**Village of Somers
7511 12th Street
Somers, WI 53171**

**Village Work Session Meeting
Agenda
Tuesday, May 20, 2025
5:30 p.m.**

**VILLAGE OF SOMERS
VILLAGE BOARD
WORK SESSION ITEM MEMORANDUM**

TO: Village of Somers Plan Commission
FROM: Luke Godshall, Senior Land Use Planner
APPLN DATE: 03-28-25
RPT DATE: 04-28-25
MTG DATE: 05-12-25
RE: Willow Creek Rezoning & Preliminary Plat

OVERALL GRADING & EROSION CONTROL PLAN

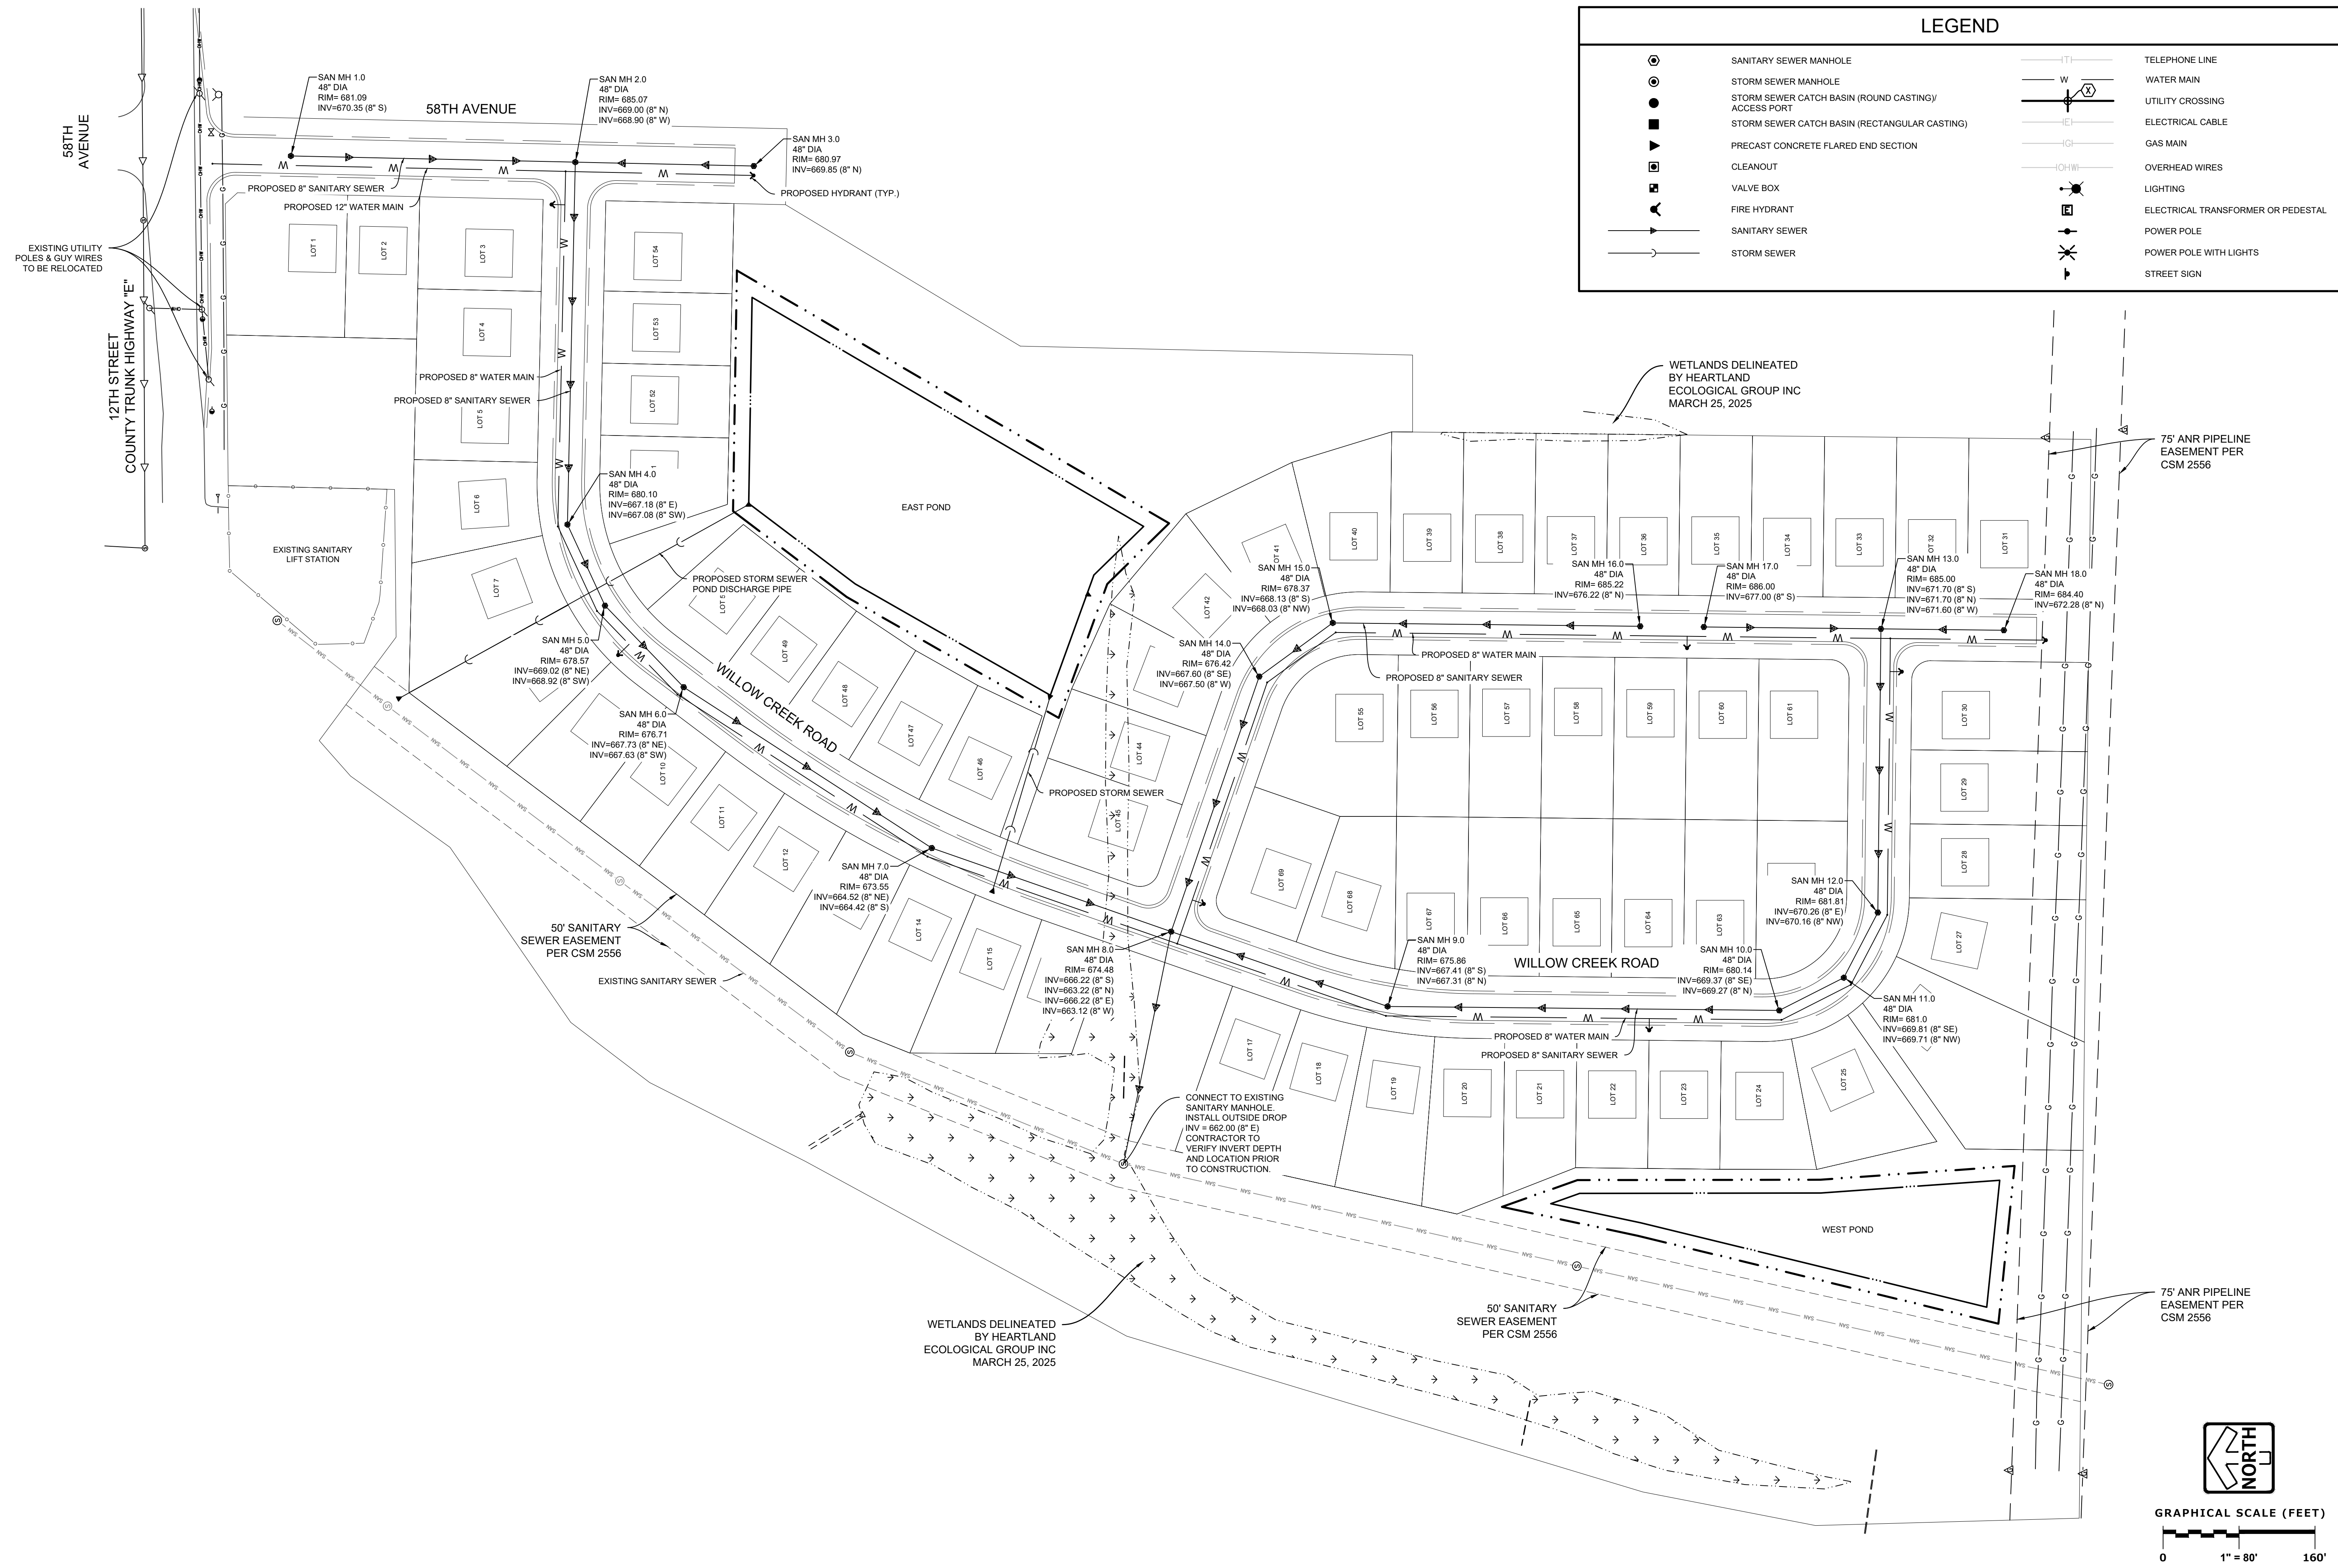
1. Sheet 3: Provide an emergency pond overland flow route.
2. Sheet 4:
 - a. Provide a 24-inch water main on the entrance road (58th Ave.).
 - b. The east pond discharge conflicts with an existing sanitary manhole.
 - c. The sanitary sewer tie-in manhole has an existing outside drop. As-builts have been provided.
 - d. Provide permit for wetland disturbance.
 - e. Provide an 8-inch sanitary sewer stub and easement to serve property to the east.
 - f. Coordinate future water main and sanitary sewer extensions to the south with the gas pipeline utility.
